## Green belt remains green belt

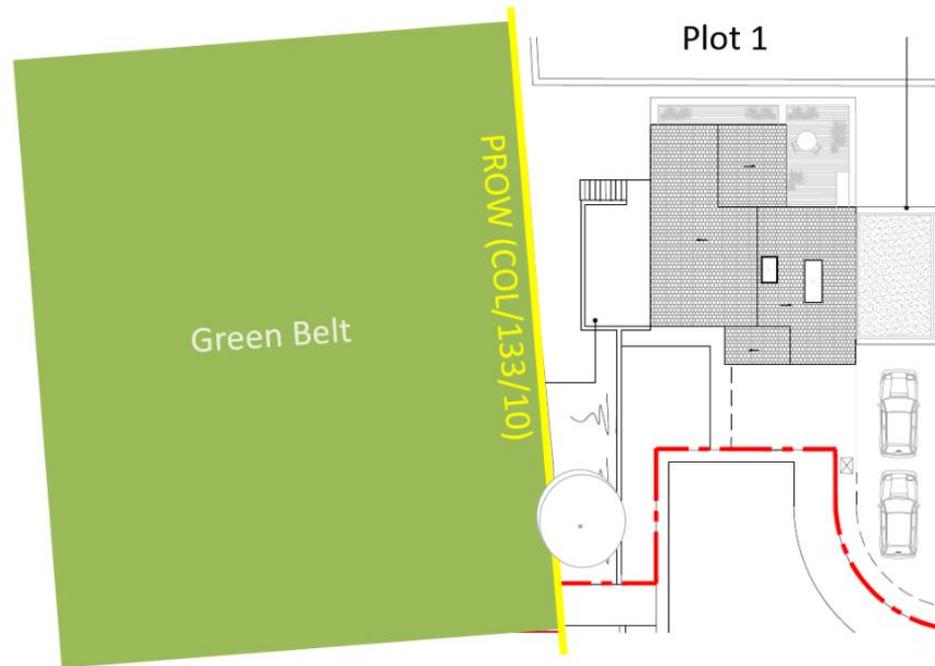
To the northwest of the site lies designated Green Belt land where permission has been granted for the installation of an attenuation tank: *see photograph above*. While the tank is required to be buried underground, the natural slope of the land means that part of the structure will protrude above the original field level. This exposed section is to be covered with soil, resulting in a raised landform that cannot be returned to its original state. Planning documents acknowledge that this specific footprint is permitted to remain altered. However, by implication, the remainder of the field—beyond the tank’s immediate footprint—**must** be reinstated to its original contours and character: *see image below*.

The photograph above shows how much soil was dumped on the green belt before the attenuation tank was even started.

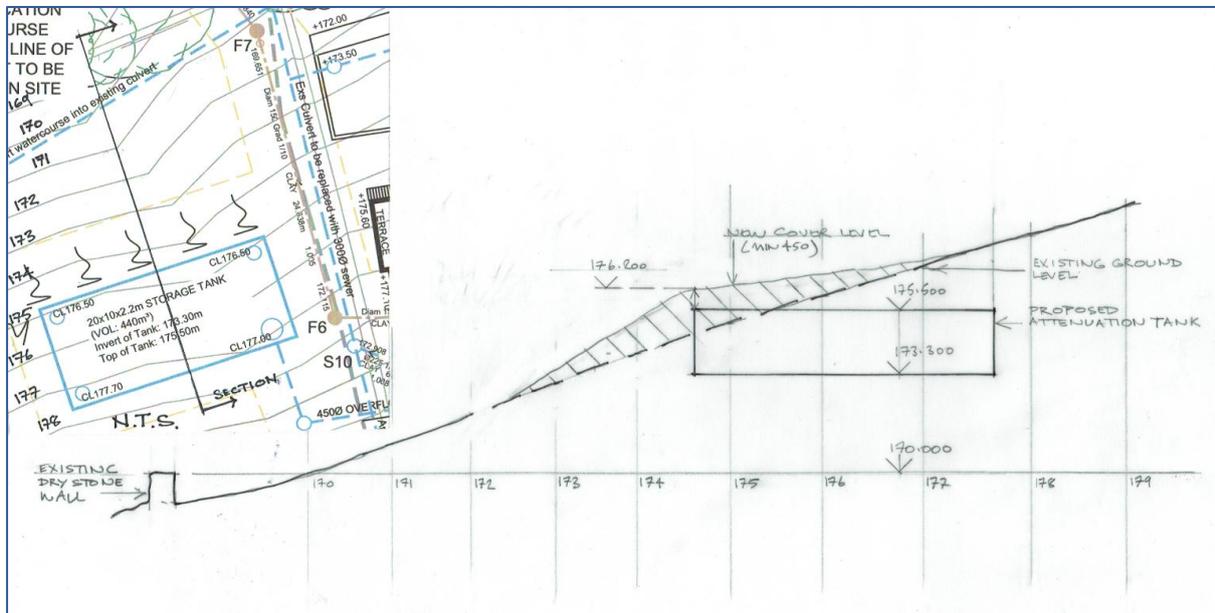
The proposed design for Plot 1 fails to acknowledge the sensitivity of its setting—immediately adjacent to both designated Green Belt and public right of way COL/133/10. Rather than responding to this context with restraint or landscape integration, The design risks giving the impression that the Green Belt has been subsumed into the dwelling’s private outlook.

From within the dwelling, the elevated position may offer far-reaching views that are undoubtedly desirable to the occupant. But from the Green Belt or PROW, the experience is markedly different. There is no soft edge, no transitional landscaping, and no visual containment. The

building dominates the scene—its massing, glazing, and architectural assertiveness shows minimal regard for principles of edge-softening and contextual design.

Urbanising the Green Belt in this manner diminishes its value—not just visually, but symbolically. The dwelling becomes a picture-framed portal into private life, standing in stark contrast to the openness and rural character the Green Belt is meant to preserve.

Under **Kirklees Local Plan Policy LP32**, development adjacent to the Green Belt must protect landscape character and visual amenity. The current proposal does not achieve this. Instead, it imposes a hard architectural edge onto a soft landscape corridor, eroding the boundary between built form and protected land.
